## Annex D - St Andrewgate

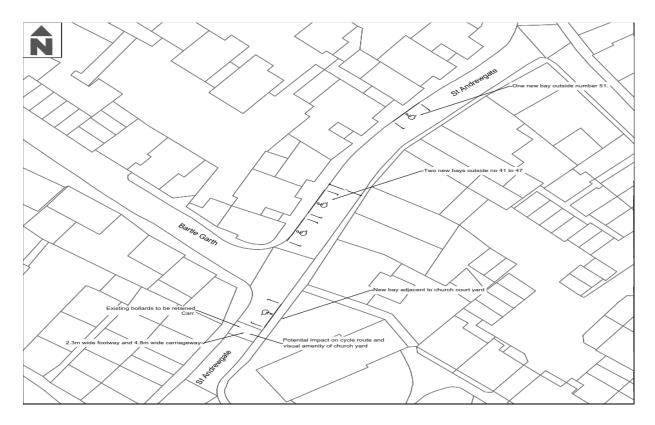
I think that marked bays would be preferable to just parking on the double yellow lines at this location. Currently, Blue Badge holders park on the double yellow lines on both sides of the road. Increasingly often (as Covid restrictions lift) the cars are parked too close to each other.  The first car to park (closest to the bollards) has been "boxed in" by the cars that have arrived later. Last month, there were four in a row which prevented the large Boyes delivery lorry from making the turn into Bartle Garth, forcing the driver to reverse back down St. Andrewgate into the path of cyclists. Of course, the larger congestion issue at this location is *still* the number of taxi and take away drivers who regularly park on the double yellows for "just five minutes" but then prevent	up on goodram gate. not all disabled badge holders have good mobility to walk long distances.	we are looking at mitigation measure around the pedestrian

There must be NO impact on the cycle route. The parking space must be distant from the bollards, or else people will block the through-access for bikes.	the parking is proposed to leave sufficient width for cyclists through the bollard
Again I think this is a dangerous location to be encouraging extra vehicle traffic. It is currently well used by pedestrians and cyclists. The access road leading to this area is a key north/south cycle route. In addition at busy times there is a high probability of Blue Badge holders arriving only to find all spaces are full and having to turn around and go out again - all of which further increases risk to pedestrians and cyclists and detracts from this area providing a quiet accessible walk/cycle route. Currently the route is enjoyed by disabled cyclists and the cycle parking near Barnitts is one of the few convenient city centre locations that are close enough to the shops to be useful for disabled cyclists. By making this route more dangerous for pedestrians and cyclists it will limit access for disabled people who use a cycle as a mobility aid.	it is a location already used by Blue Badge holders and we are only looking at formalising the parking situation with marked bays thank you for your comment

This is an area often blocked to bikes at the bollards by blue badge parking. This is a bad area for parking on double-yellows and this area needs dedicated blue badge bays. At the same time, stop making blue badge access an afterthought after loading, deliveries and local businesses. If the council wants to be truly anti-discrimination, then access to city centre for disabled people needs to be unconditional and without having to beg, wait or be frustrated!	thank you for your comments, the proposal could look at amending the layout of the bollards to create more space for cyclists
This would mean I could go to Barnitts again - a shop I love but currently cant access	thank you for your comments
If the parking is controlled so that unauthorised parking in Aldwark and St Andrewgate stops, they will be invaluable	thank you for your comment
A very useful area to have dedicated bays however 3 isn't many .	thank you for your comments

It is good to have specific bays on St Andrewgate but not next to the bollards as this prevents emergency access for ambulances. Bays should not be opposite private garages nor should there be a bay at the end of Bedern. I live in Aldwark and blue badge parking is a huge problem for residents with garages and anyone needing access to Bollans Court and Margaret Philipson's Court. The garages are narrow and cars need the full road width to reverse out. Many of the garage owners also have blue badges.	the proposed bays will not obstruct junctions or private garages and vehicle tracking has been undertaken
Could be more here	thank you for your comments
The location map above and the proposed locations on your ArcGIS Blue Badge Parking Bay Survey don't agree with each other!! Parking Bays nearer to Kings Square are better for BB holders who can't walk very far.  No	thank you for your comment and suggestion

Need to ensure the parking doesn't make the cycle route through this area more dangerous due to sightlines being poorer or disabled drivers opening car doors into the path of cyclists.	thank you for your comments and information on potential traffic issues in the area
Good place for city access and good pavements but are plans going through for Barnitts to be turned into housing on that road?	thank you for your comments, there is a planning application for Barnitts but it will not affect the highway layout
